**Subject: NRC Request for Additional Information, Docket No. 71-9319, TAC No. 24069**

**Reference: 1) NRC Request for Additional Information for Review of the Model No. MAP-12 and MAP-13 Packages, dated September 6, 2007.**

**Document Identification No.  
51-9026593-001**

**Application for Certificate of  
Compliance for the  
MAP Series of PWR Fuel  
Shipping Packages**

Figure 3-2 - Heat-up of MAP Package under NCT Hot Conditions with Insolation (Enlarged View)

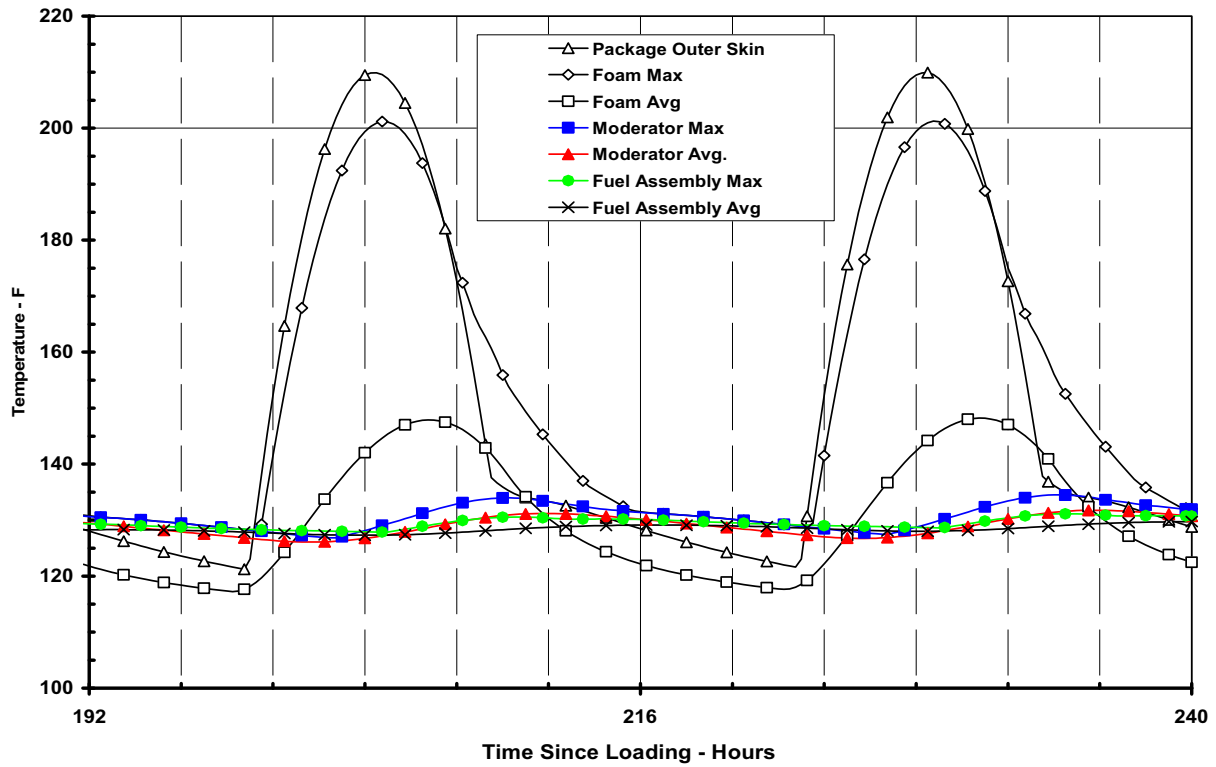
14	Section 3	Revised identified pages to incorporate omitted references (RAI 3-1)
15	Sections 3.3, 3.3.1.1, and 3.5.2	Modified sections and added new Figure 3-2 to present enlarged view of transient shown in Figure 3-1 (RAI 3-2)
16	Sections 3.2.1 and 3.5.2	Modified sections to describe how the solar absorptivity values listed in Table 3-6 of the SAR were applied to the thermal model (RAI 3-3)
17	Section 3.4.2	Modified section to clarify the sequence of events related to the fire test of the MAP (RAI 3-4)
18	Section 3.4.2	Modified section to include justification for the heat input ratio between the regulatory and fire test results (RAI 3-5)
19	Section 3.2.2 and 3.4.3	Modified Sections 3.2.2 and 3.4.3 to provide clarification of the basis for the estimated temperatures reached during the fire (RAI 3-6)
20	Section 3.4.3.1	Add more detailed discussion as further provided in Section 2.12.1 (RAI 3-7)
